Work Order ID 153248

Item Name: Left Hand Pilot in Command - Medium/Standard Design, Complete 212/412

DART SERVICE INSTRUCTION

TO AMEND INSTALLATION INSTRUCTIONS IIN-D212-803 REV. D AND INSTRUCTIONS
FOR CONTINUED AIRWORTHINESS ICA-D212-803 REV. 3 OR LATER APPROVED REVISION
REF. FAA STC: SR02233SE

FIGURE 1 - Co-Pilot Collective Head Installation
D4410-041 SHOWN D4410-043/-045 AND D5046-041/-043/-045 SIMILAR)

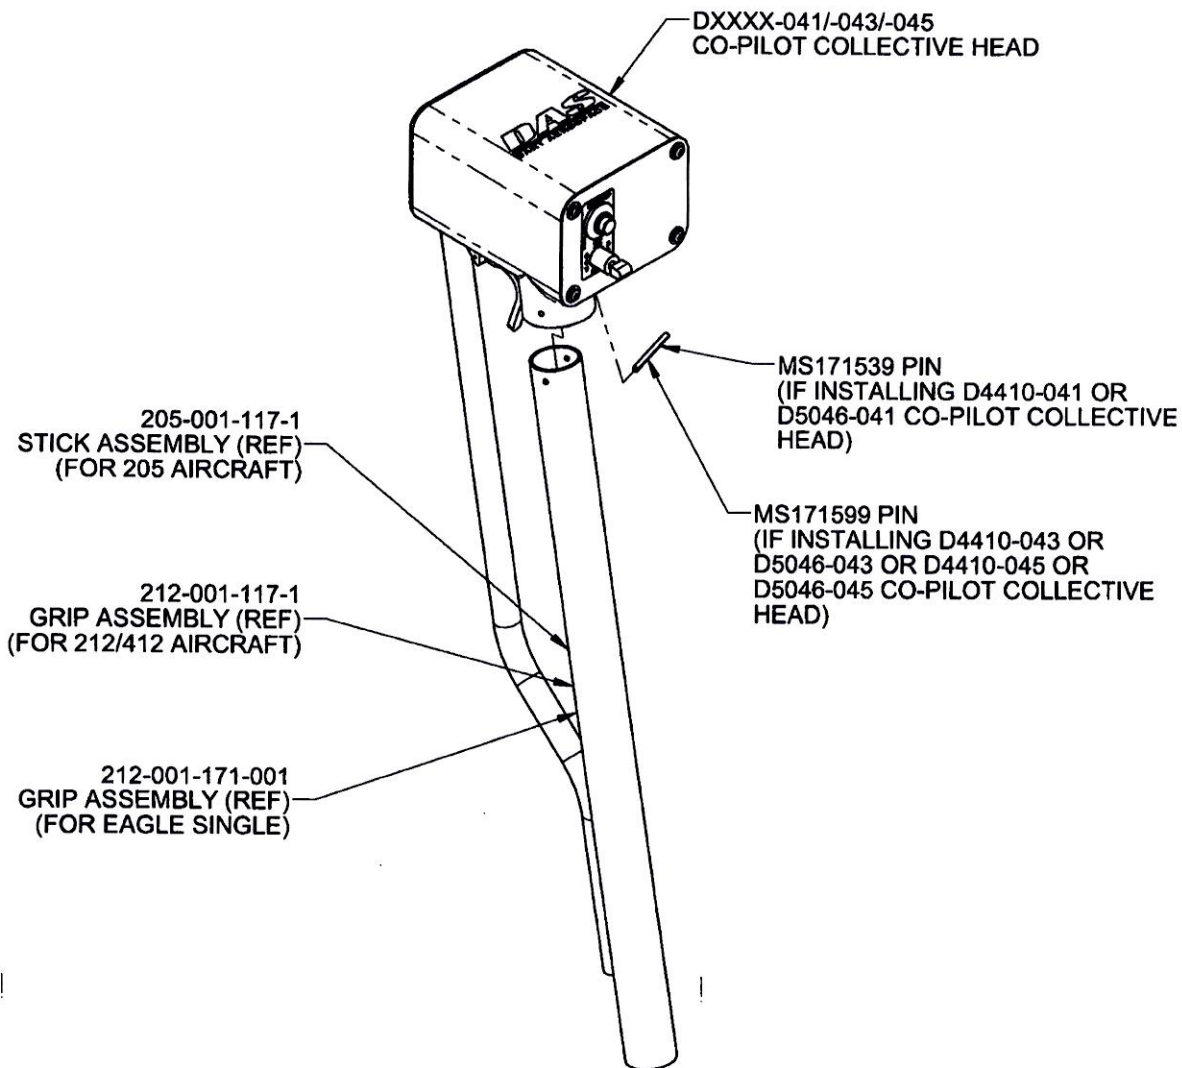
The purpose of the DSI is to amend the installation of the D4410-041/-043/-045 Co-Pilot Collective Head Assembly and the D5046-041/-043/-045 Co-Pilot Collective Head Assembly on the Collective Stick of the Bell 205/212/412 model aircraft for DXXX-803-0XX at CHG 003 and later and the DXXX-803-1XX at CHG 002 and later.

2.1 To install DXXXX-041/-043/-045 Co-Pilot Collective Head Assembly onto Collective Stick Assembly (Bell p/n 205-001-117-1 for 205, Bell p/n 212-001-117-1 for 212/412 and Bell p/n 212-001-171-001 for Eagle Single), position the Head Assembly on the Collective Stick Assembly so that it is angled away from the door and does not contact the pilot's leg. Transfer drill the mounting hole on the Collective Stick Assembly to the desired location on the neck of the DXXXX-041/-043/-045 Collective Head.

2.2 To adjust the position of the DXXXX-041/-043/-045 Collective Head Assembly, it is acceptable to remove 1/2" to 3/4" off of the neck as desired.

2.3 Wet the Collective Head Assembly with Proseal 890 or equivalent and mount using Pin (p/n MS171539 on DXXXX-041 Collective Head or p/n MS171599 on DXXXX-043/-045 Collective Head) per Figure 1. Apply Aircraft Primer to Pin.
